CUYAMA BASIN GROUNDWATER SUSTAINABILITY AGENCY STANDING ADVISORY COMMITTEE

Cuyama Basin Groundwater Sustainability Agency

Groundwater Sustainability Plan Update

Figure 2.2-7: Central Cuyama GW Basin Wells and Hydrographs by Data Source
 Cuyama Basin Groundwater Sustainability Agency
 Cuyama Valley Groundwater Basin Groundwater Sustainability Plan
 August 2018

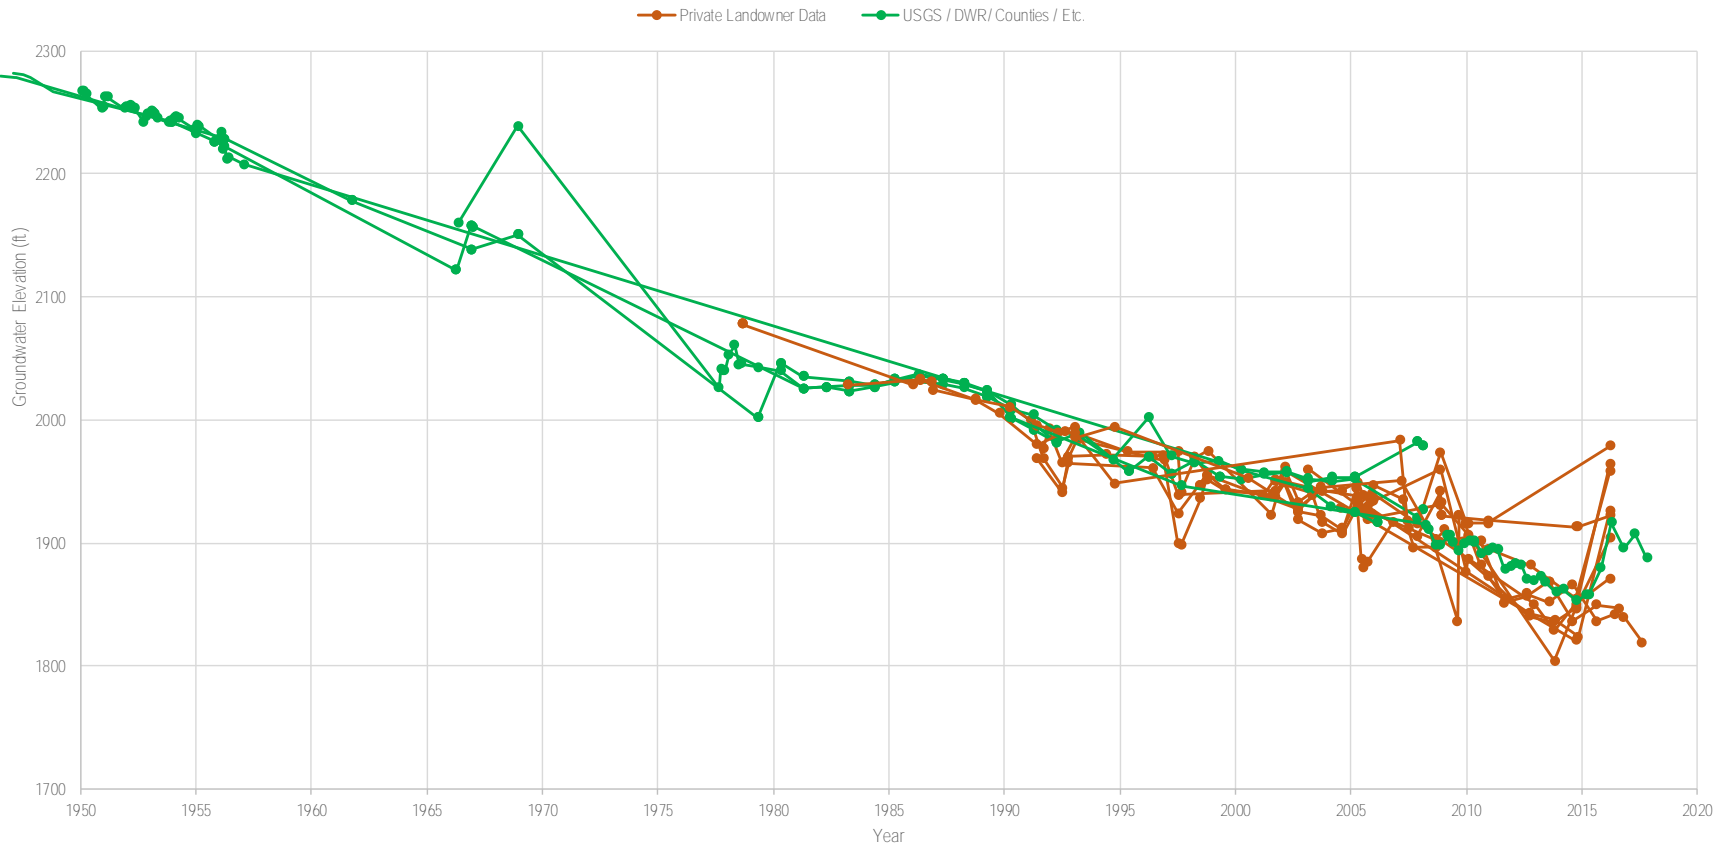
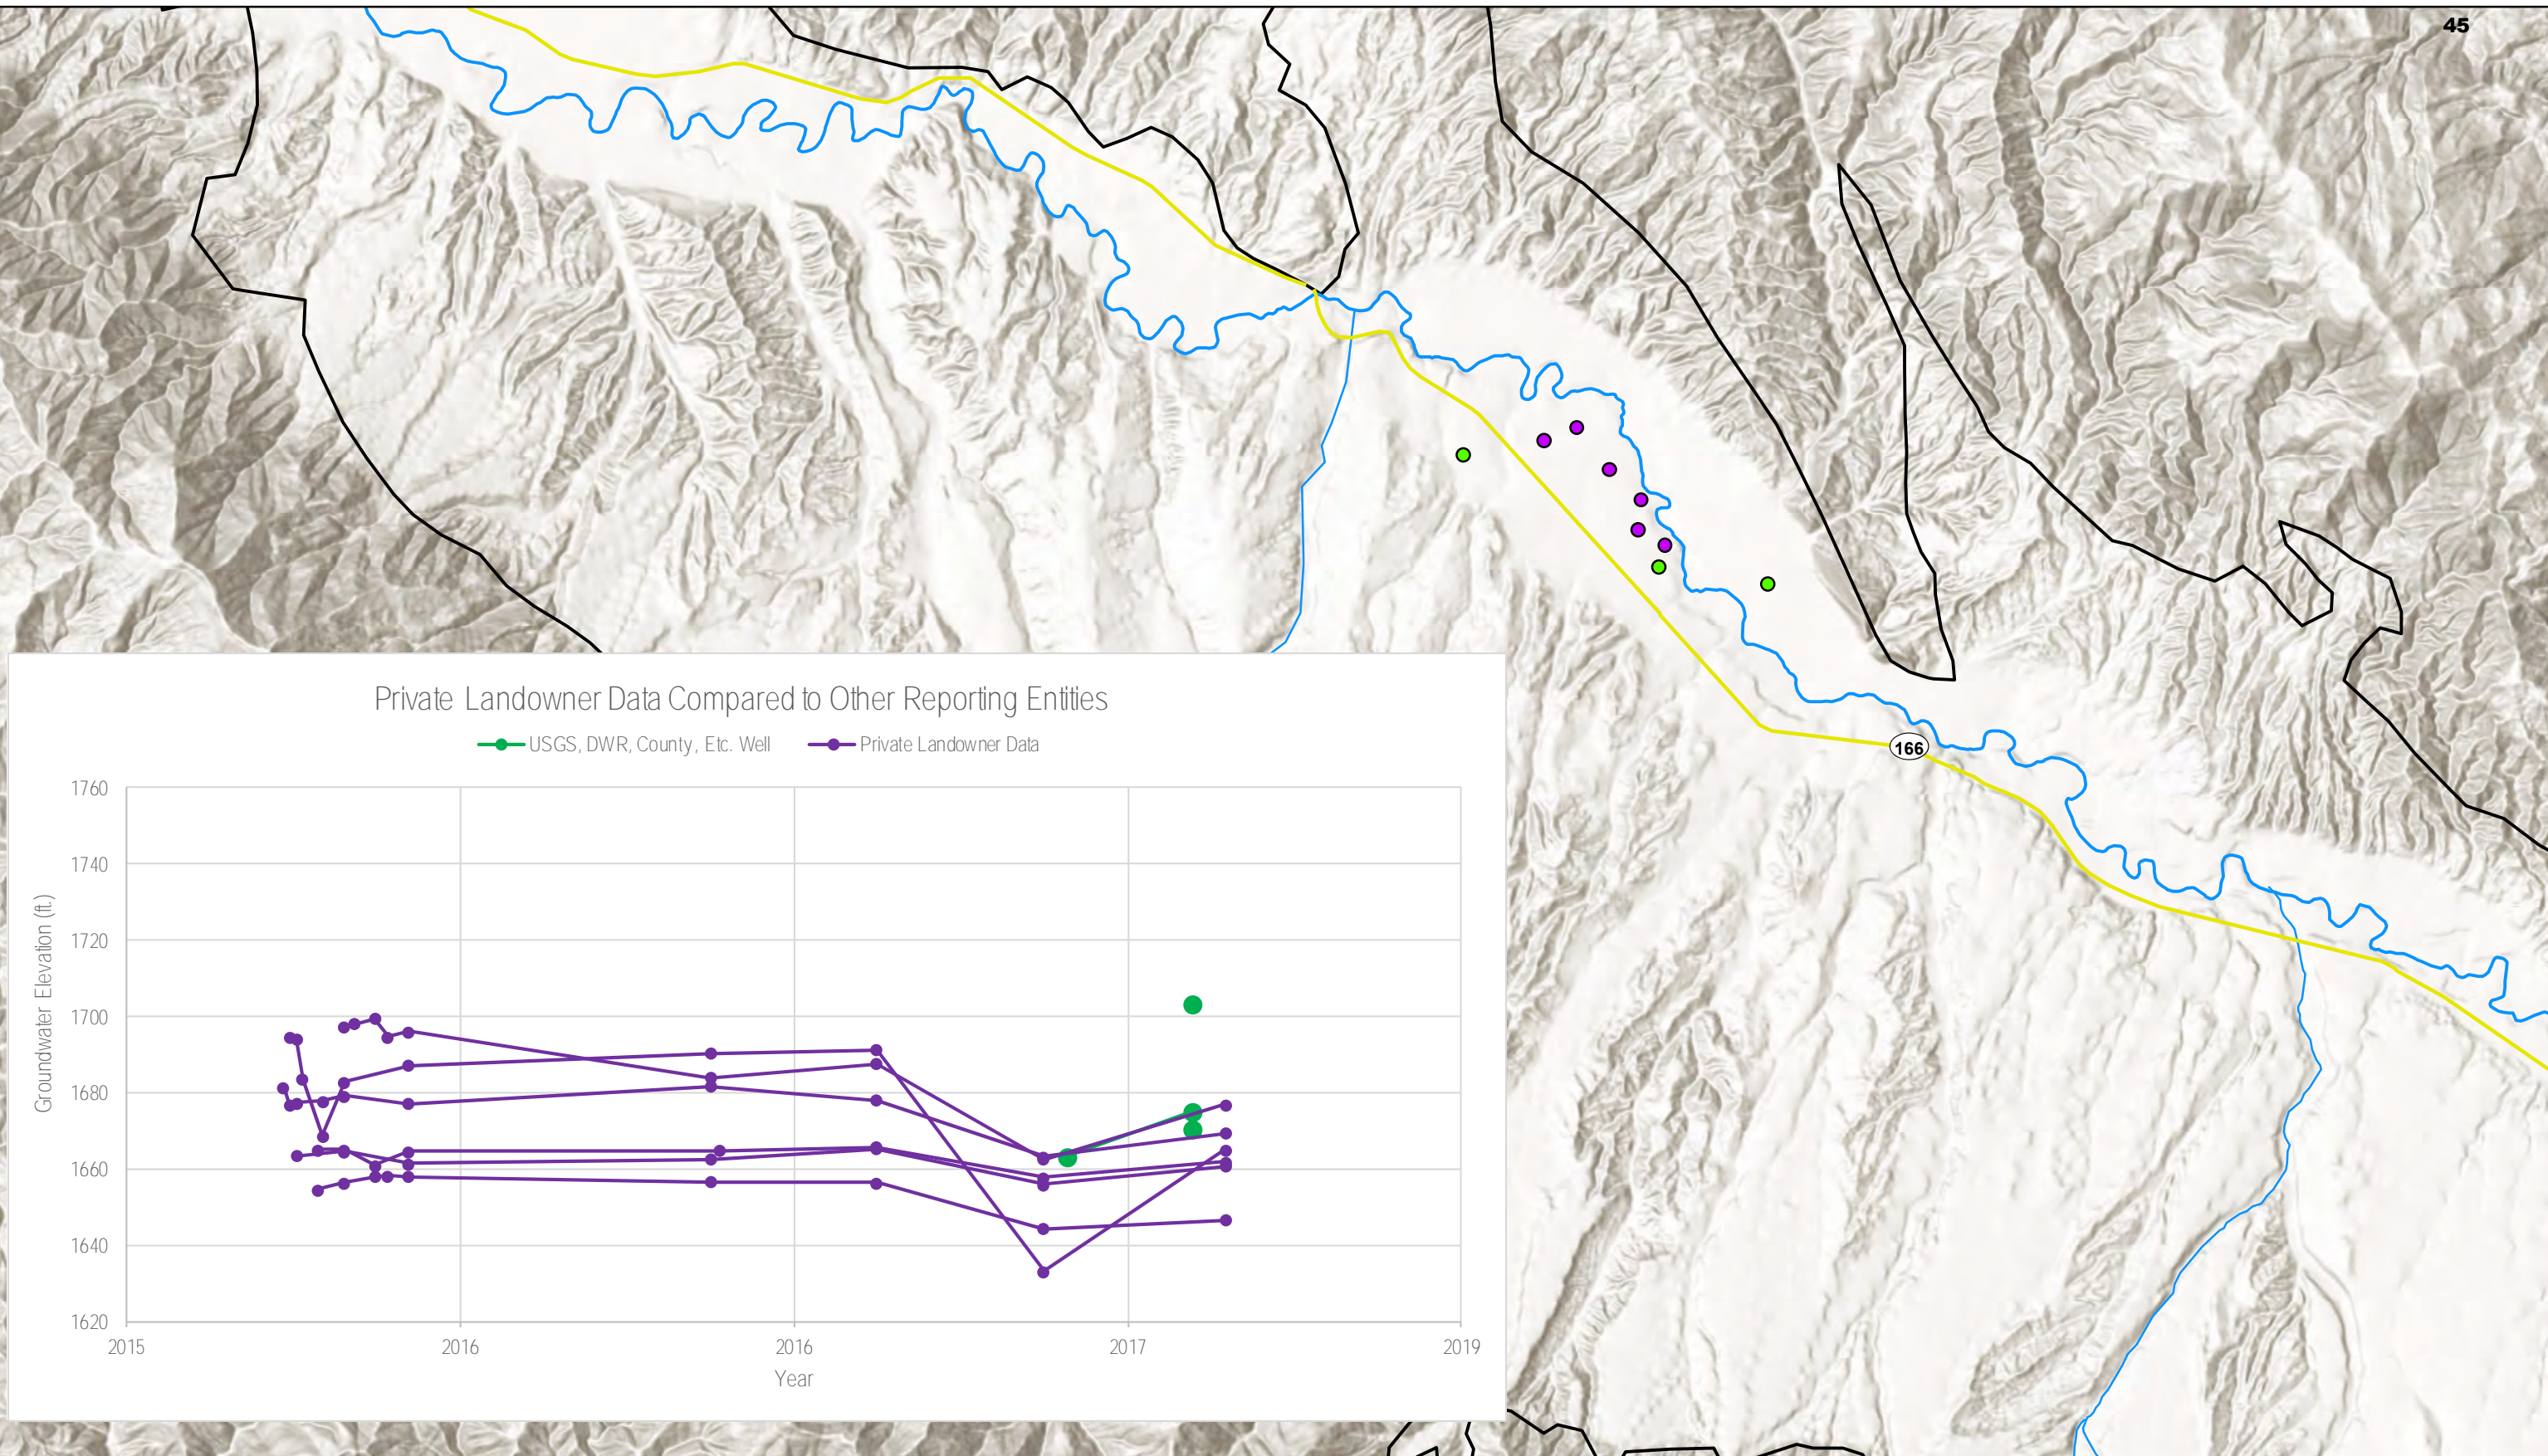
132	Matt Young, Matt Scrudato, & Fray Crease	Santa Barbara County Water Agency	2.2.2 GW Elevation Data Processing			Figure 2.2-7 shows a comparison of data	Need context to explain why this comparison is being done.	Text has been revised for clarity.
133	Matt Young, Matt Scrudato, & Fray Crease	Santa Barbara County Water Agency	2.2.2 GW Elevation Data Processing			Figure 2.2-8 shows a comparison of data	Need context to explain why this comparison is being done.	Text has been revised for clarity.
134	Matt Young, Matt Scrudato, & Fray Crease	Santa Barbara County Water Agency	Figure 2.2-8				The need for this statement and graph appears to be validation for the quality of water level data provided by Grapevine Capital Partners. Please remove both the discussion (page 2.2-11) and the graph as these data illustrates nothing at all. 1. Two of the Santa Barbara County wells are not even part of the network. I don't even think these wells exist in the Valley. It is unclear where these data came from. 2. You appear to be comparing very shallow wells to a 6 of the 12 deep production wells. 3. Are these discrete static water level measurements used for the Grapevine data or select points from the continuous 5-minute data sets? SBCWA has been making periodic discrete water level measurements at the 12 productions wells on the Harvard property. A comparison of 26 measurements shows differences between discrete water level and computed water levels ranging from -47.9 feet to 150.36 feet. These are large outliers when compared to all the measurements, but would be a better indication of the data quality (see chart below). SBCWA has measurements from 9/2018 to compare as well. There would be some variation of only a few feet in this comparison based on equipment PSI (most likely higher PSI being used due to large level changes and therefore reduced accuracy), MP elevation choice, computation procedures, etc. Please contact Matt Scrudato to discuss specifics.	The figure is included because of interest expressed during public meetings regarding how data provided by private landowners compares with data provided by public agencies. The text describing the figure has been revised for clarity.

Figure 2.2-11: Cuyama GW Basin Hydrographs

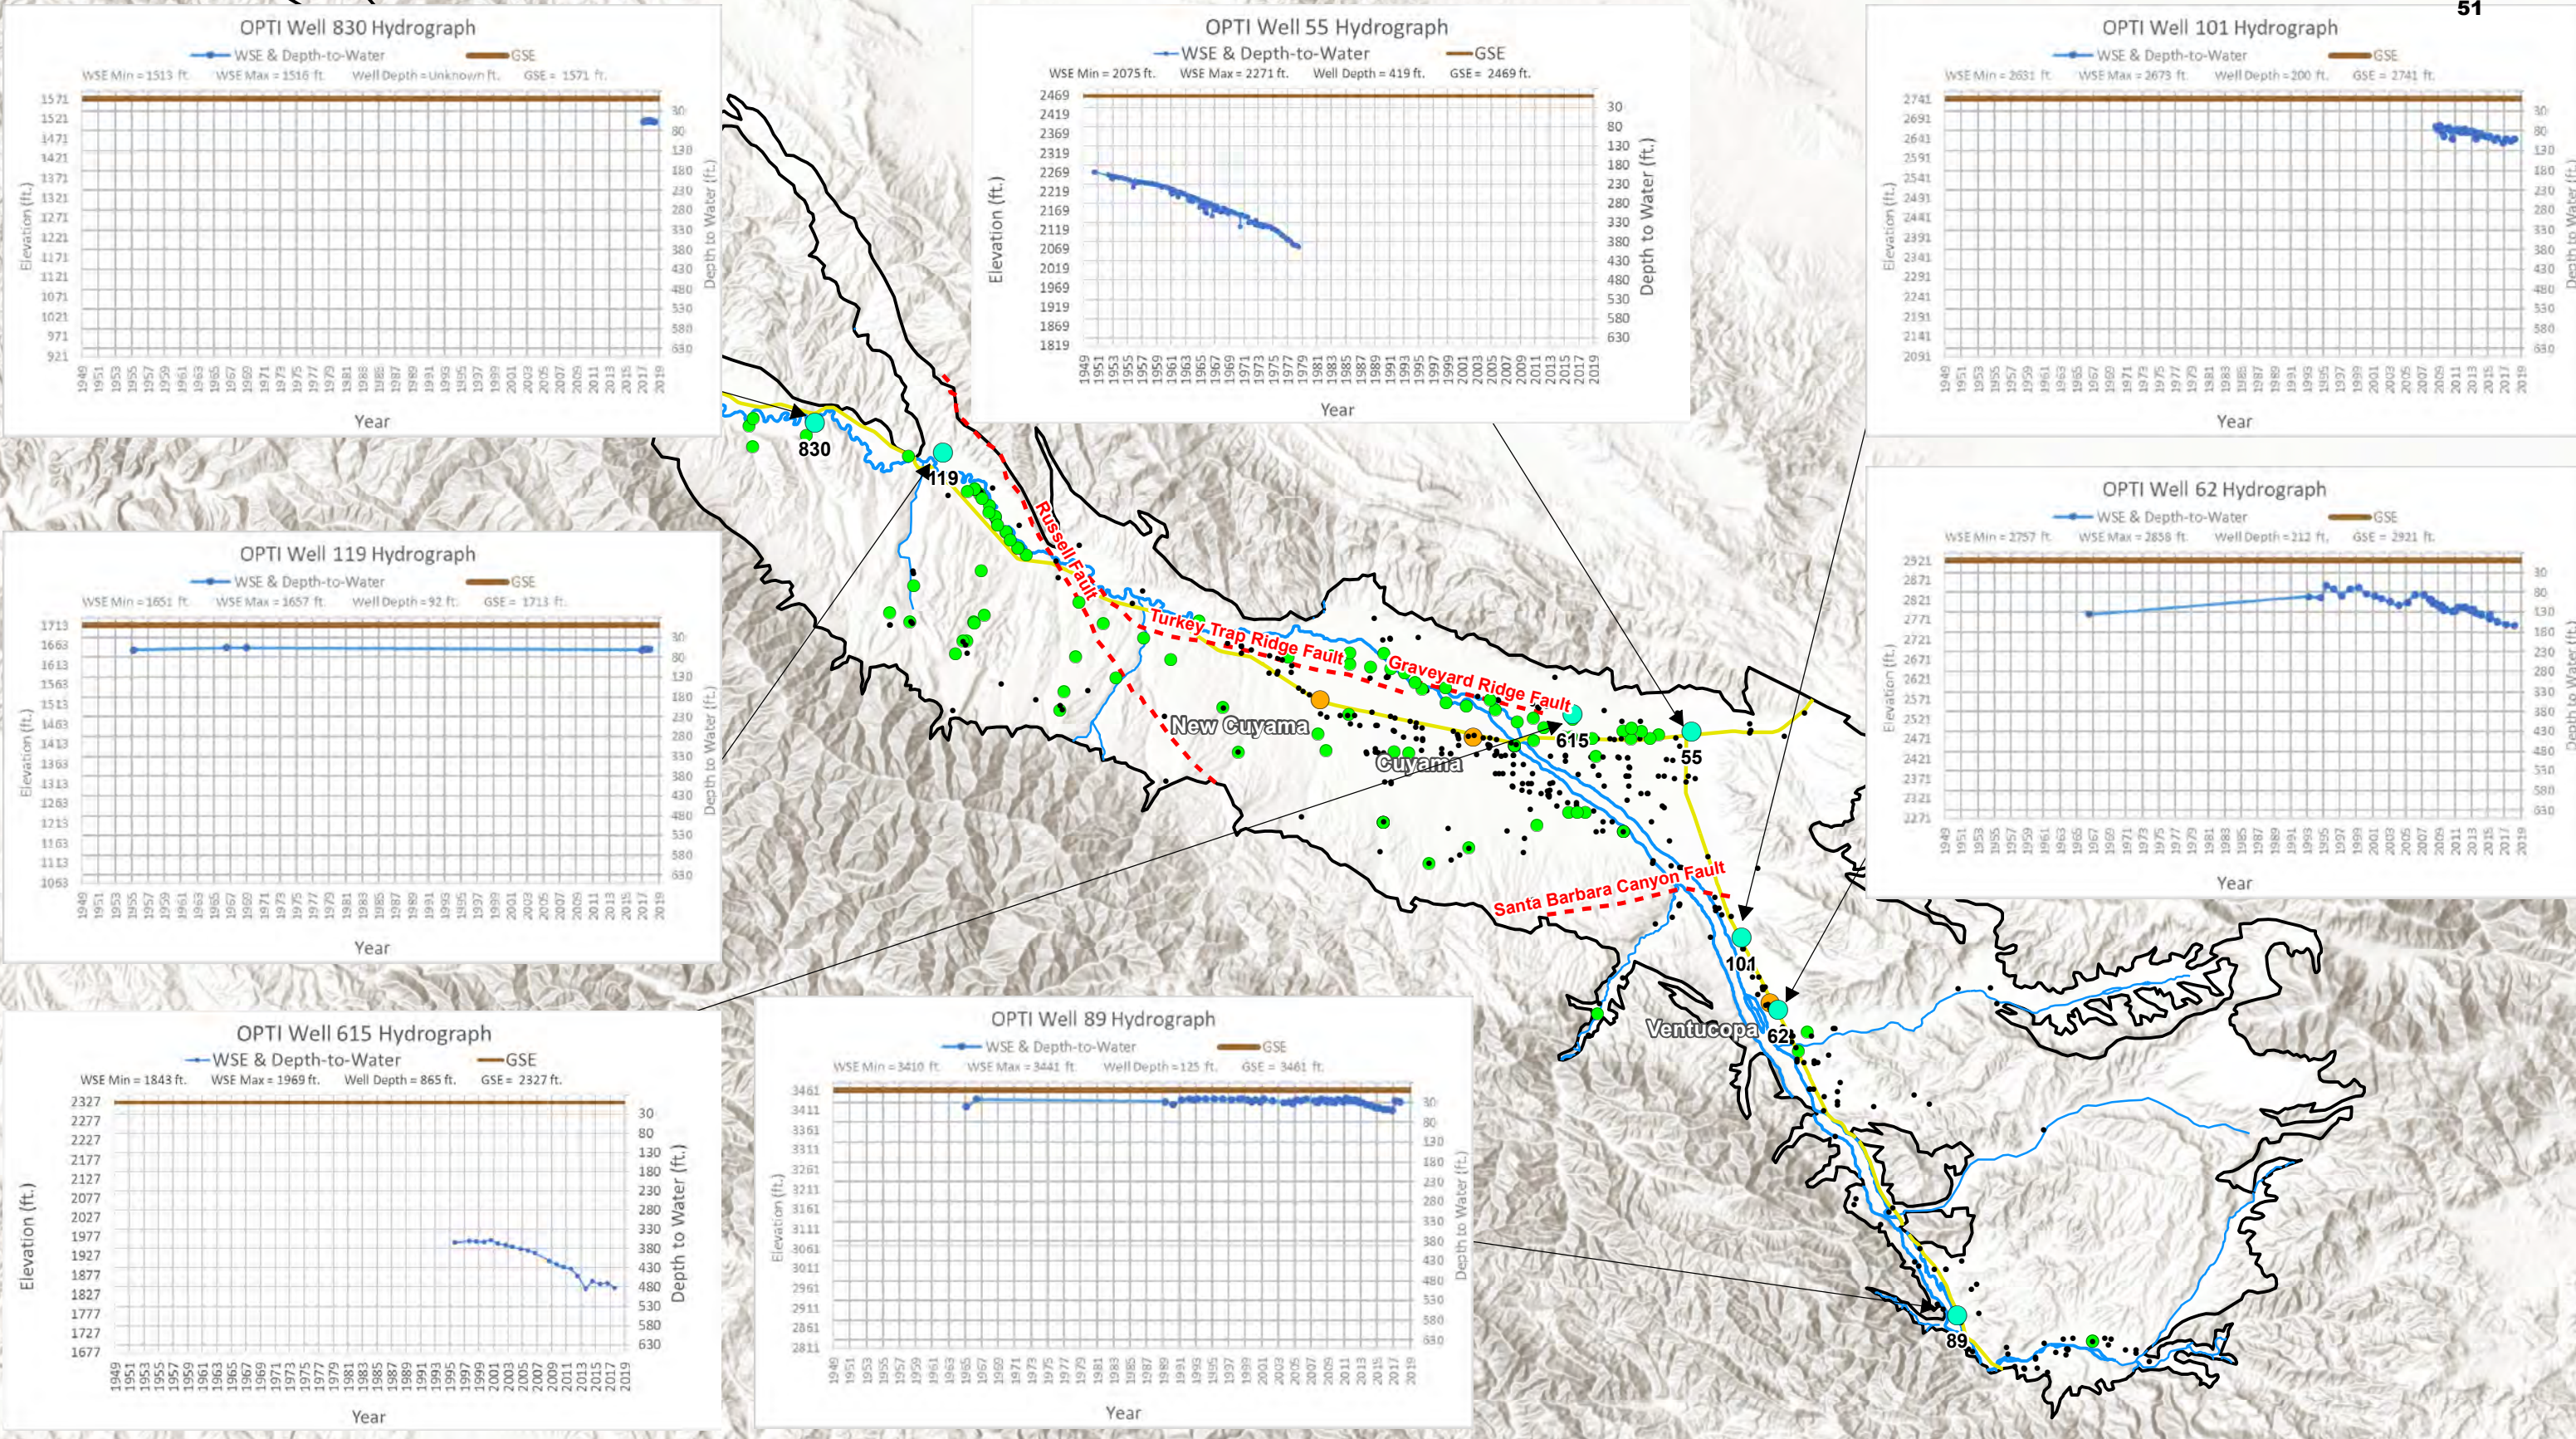
Comment #	Commenter	Commenter Organization	Section	Section Paragraph #	Paragraph's Sentence #	Sentence Starts with, "...	Comment	Response to Comment
22	Jeff Shaw, Anona Dutton, John Fio, Tim Ingrum	EKI Environment and Water	Figures 2.2-11 to 2.2-15				Hydrograph figures lack organization and their interpretation is insufficiently clear (2.2-11 to - 15). Partial overlap and repetition of hydrographs make the figures confusing. Figures should be revised so that each one exclusively covers a portion of the basin with unique hydrographs. Well 620 should be discussed under "central portion" because it is north of SBCF and follows the pattern of decline in that region. South of the fault to the Ventucopa area is showing a largely consistent picture of long-term steady elevations (Wells 40, 41, 85) with the exception of decline in Well 62 since the 1990s. The area of decline in the western portion of the basin extends to Well 70, just west of Bitter Creek. Regarding the statement that "all monitoring wells in [the central portion of the basin] show consistent declines, consider that Well 28 has elevations leveling off in the 1990s and then starting to recover in the 2000s.	The figure and text have been made consistent. Title corrected.

143	Matt Young, Matt Scudato, & Fray Crease	Santa Barbara County Water Agency	2.2.3 GW Hydrographs			Figure 2.2-11 shows Hydrographs in different portions	Please describe in the text why these wells were chosen. Are they representative of the areas?	The text and figure have been revised for clarity.
144	Matt Young, Matt Scudato, & Fray Crease	Santa Barbara County Water Agency	2.2.3 GW Hydrographs	Bullet list		In the area southeast of Round Springs Canyon	Please edit for clarity and grammar. Also, if you are going to describe the hydrographs, you should describe all of them If they want to generalize then make the graph mimic these areas, pick 5 representative hydrographs. Right now there are 7 on the Figure which looks cluttered.	The text has been revised for clarity.
145	Matt Young, Matt Scudato, & Fray Crease	Santa Barbara County Water Agency	Figure 2.2-11				Bitter Creek area - illustrate on map as a reference	This is labeled on Figure 2.2-1
